Submission of comments on Revision of ‘Annex 1: Manufacture of Sterile Medicinal Products’

ECA – European Compliance Academy

In the following diagrams, colors indicate the following:

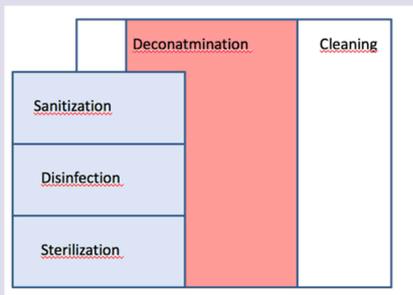
white: removing and / or inactivating any other kind of unwanted material; e.g. chemical substances, radioactive material, biological material (other than microorganisms)

blue: microbial reduction,

red: decontamination (removing or inactivating unwanted, hazardous material, i.e. for HSE reasons)
